TOWN OF CORTLANDT

ZONING BOARD OF APPEALS

Zoning Board of Appeals Work Session & Meeting

Thursday July 16, 2026

18 TRAVIS AVE. LLC
17 LANCASTER AVE.
MONTROSE, NY
WESTCHESTER COUNTY, NY
SECTION 54.8 BLOCK 3 LOT 27
PROPOSED SITE CONDITIONS PLAN

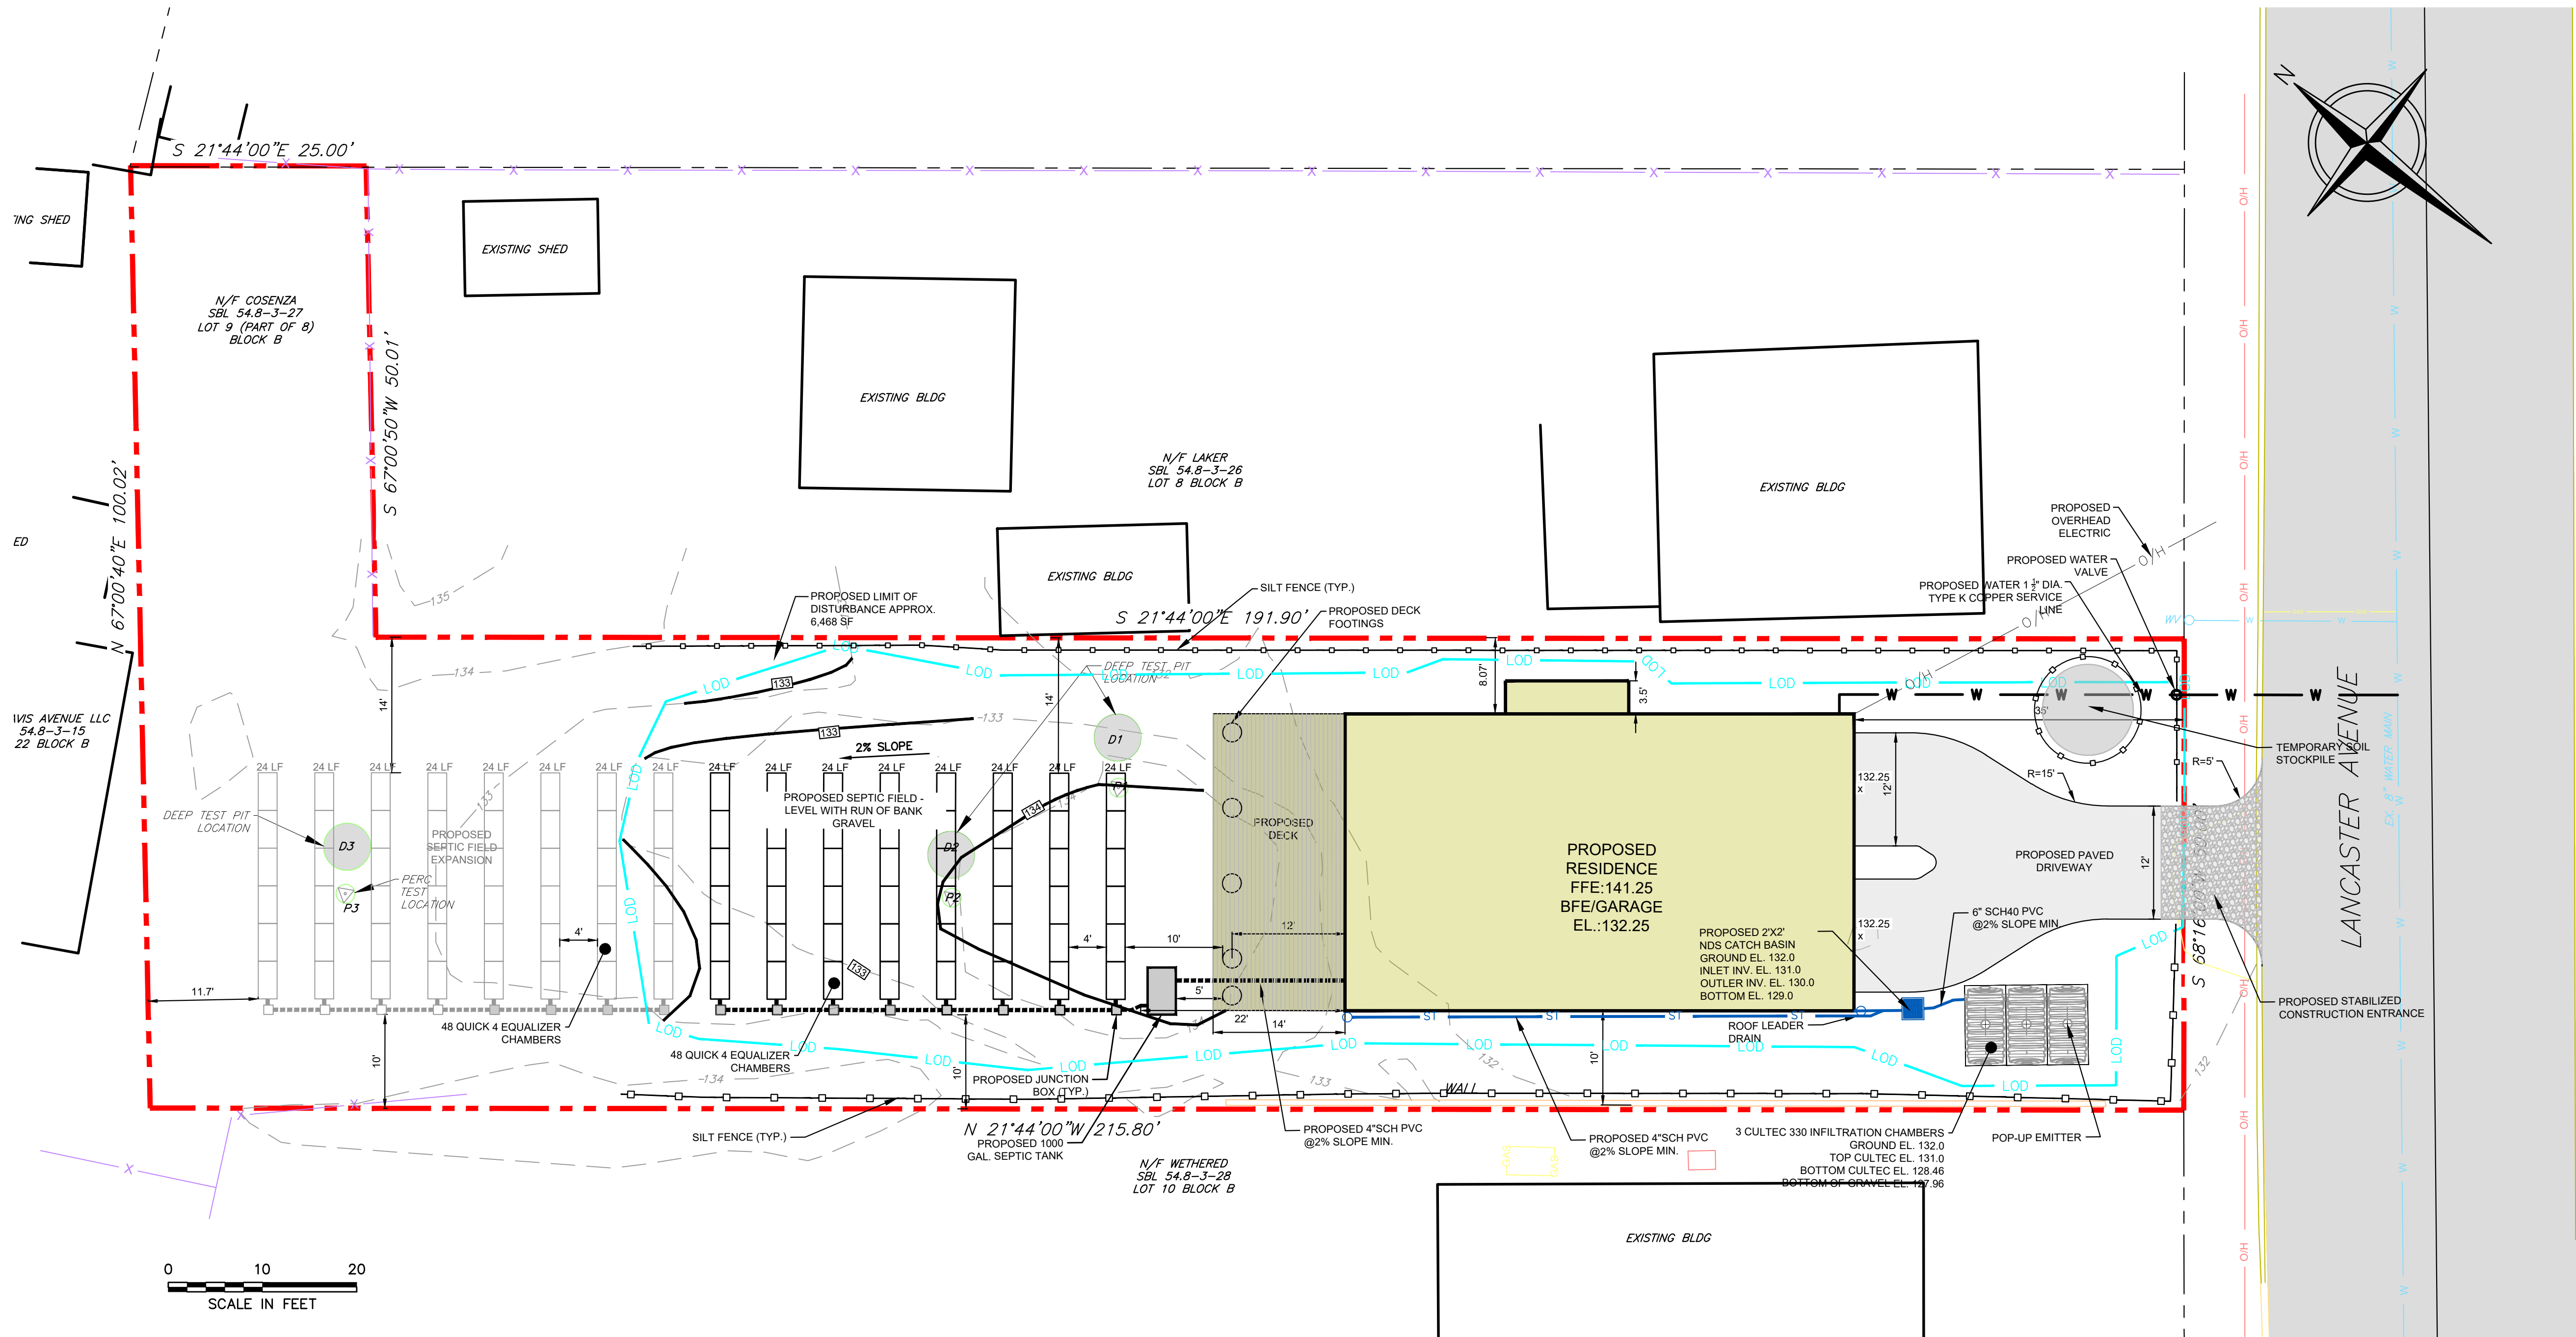
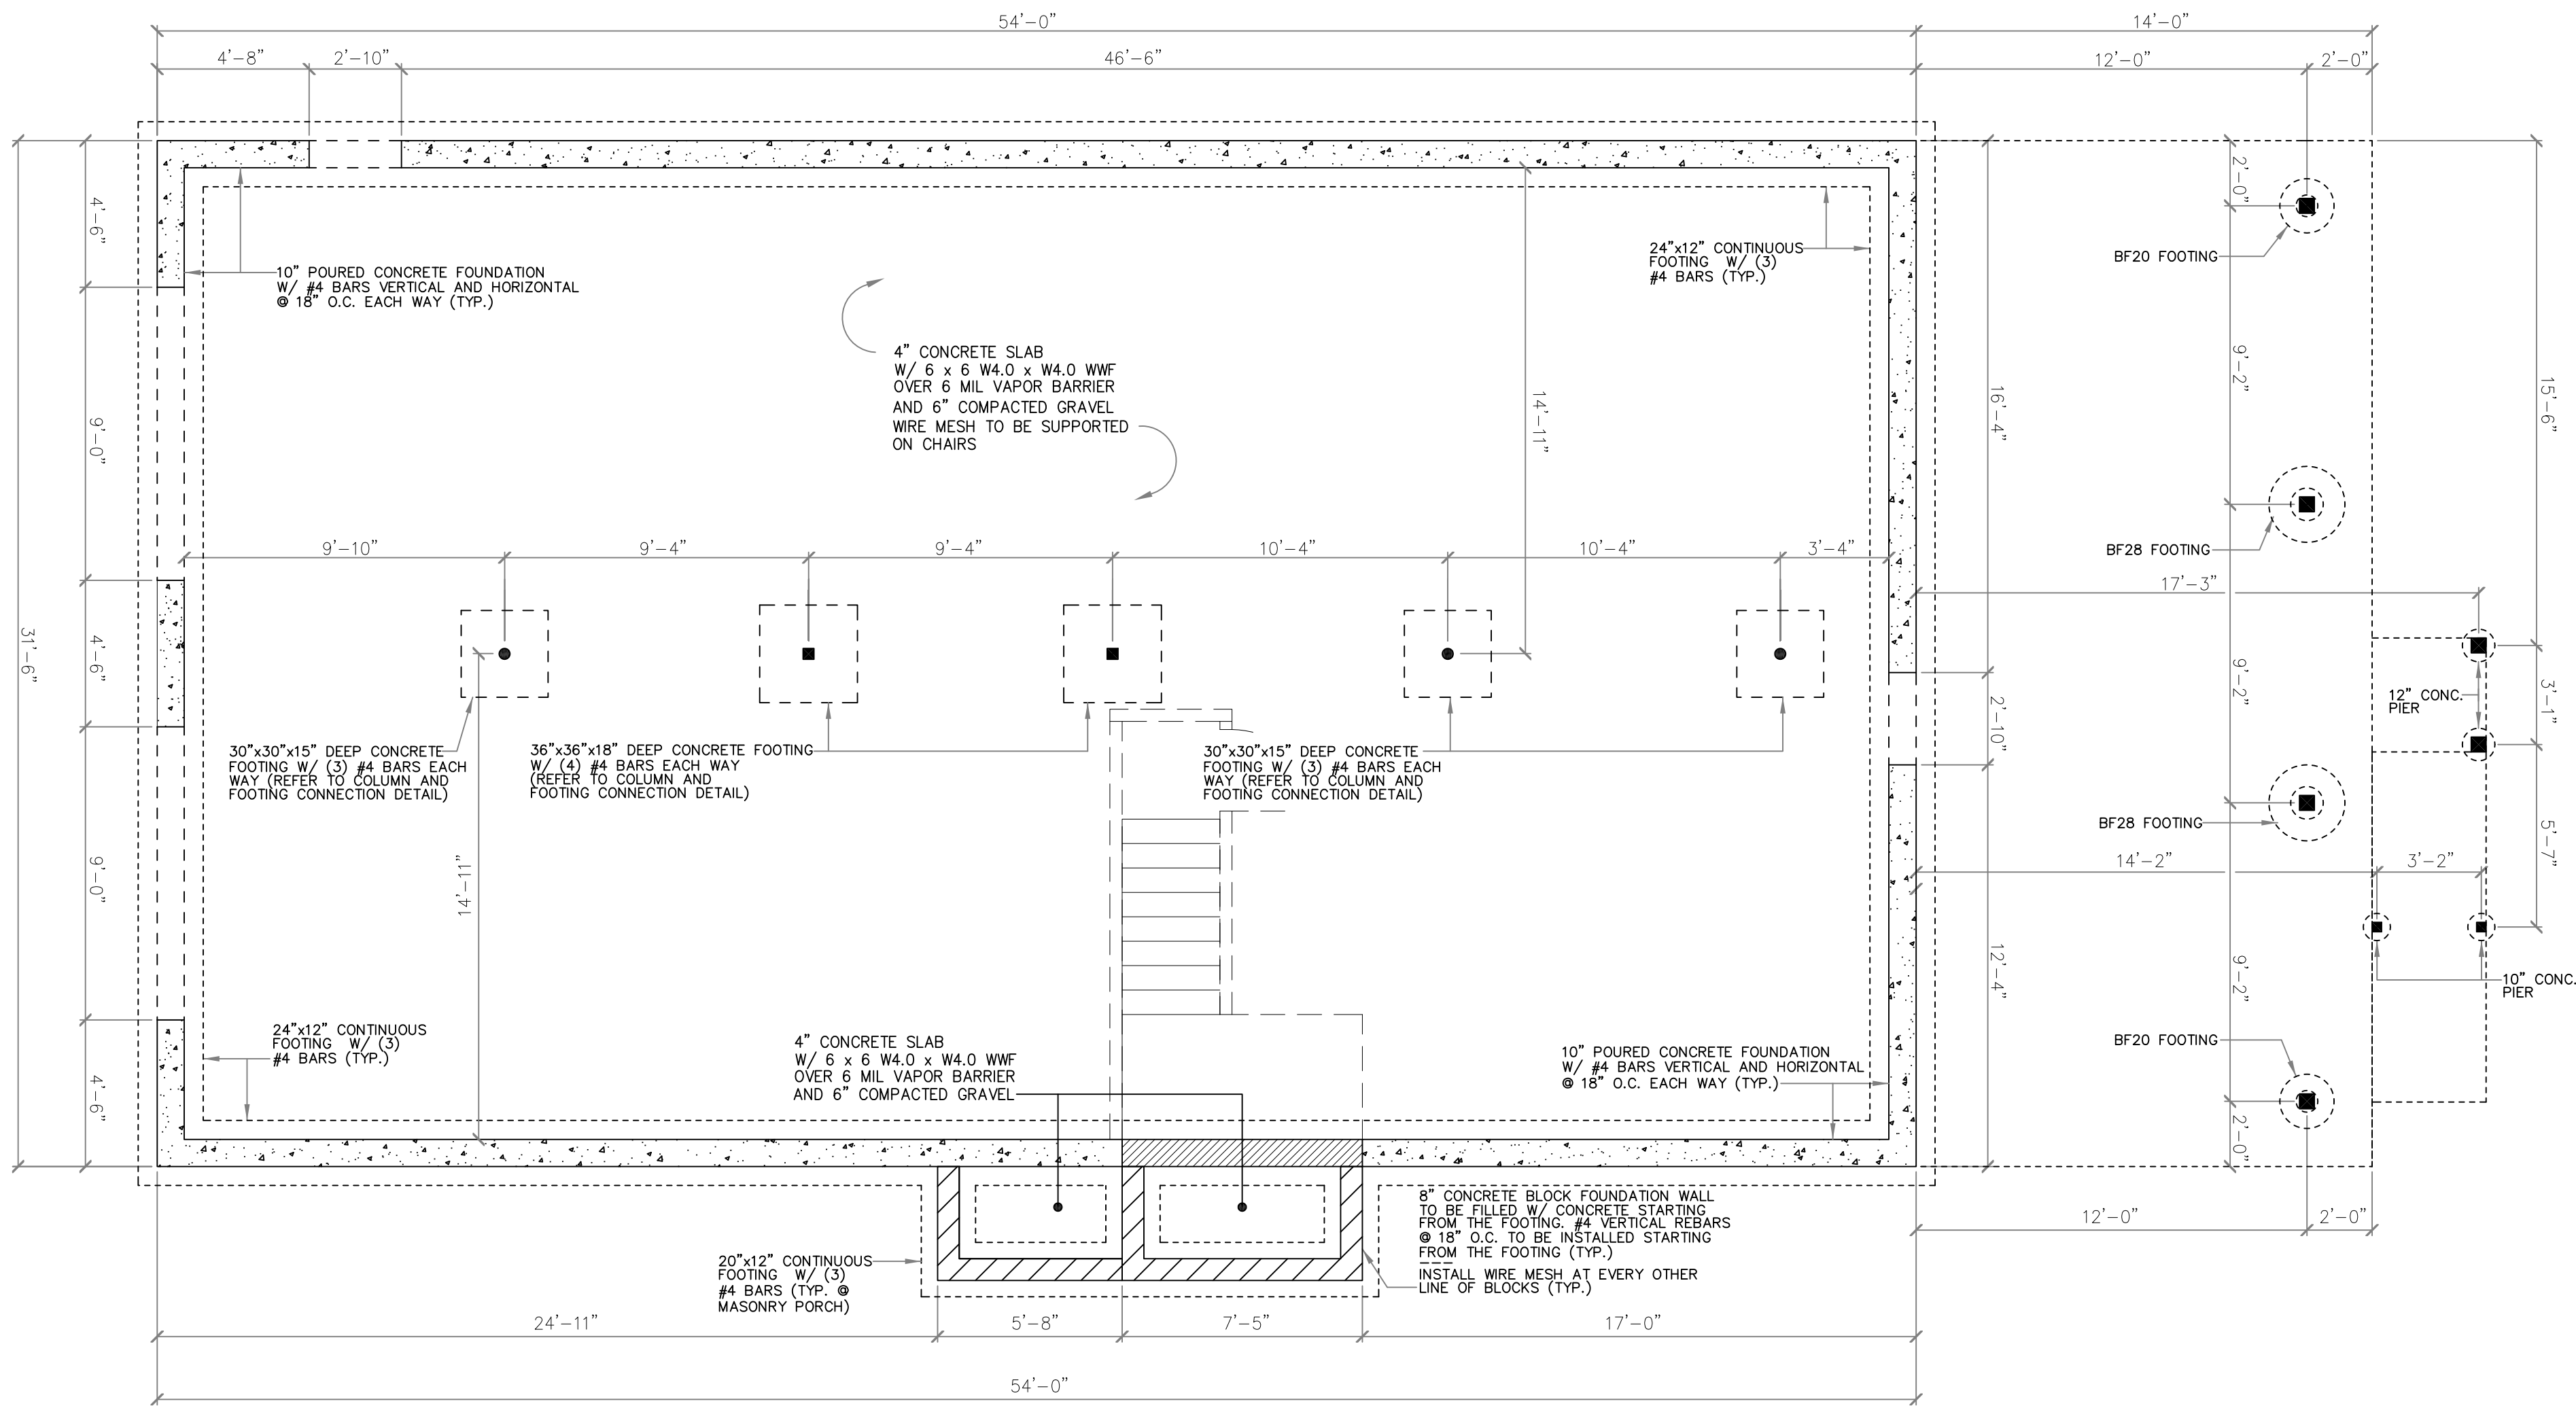
The Applicant is requesting relief as follows as shown on Drawing 1 "Site Plan and Zoning Analysis" prepared by AC Engineering PLLC.

- Variance 1 – Deminmus encroachment into side yard setback from masonry entrance steps. 8.33 ft required. 5.33 ft. s.y. allowed (with 3-ft encroachment). 4.57 ft. shown. This means a .76 ft or 9" variance is necessary. Zoning Code Reference: 307.18 B-3

- Variance 2 – 369 square feet of additional floor area. (3494-3125)
- Zoning Code reference: 307 Attachment 4

- Variance 3 – 141 square feet of building coverage. (2172-2031)
- Zoning Code reference: 307 Attachment 4

Variance 4 – Minimum lot size required 15,000 Sq. Ft. Existing 12,067 Sq. Ft. Requiring 2,933 Sq. ft of relief.

1. Property survey
2. Drawing 1, Site plan and Zoning Analysis
3. Floor Plan
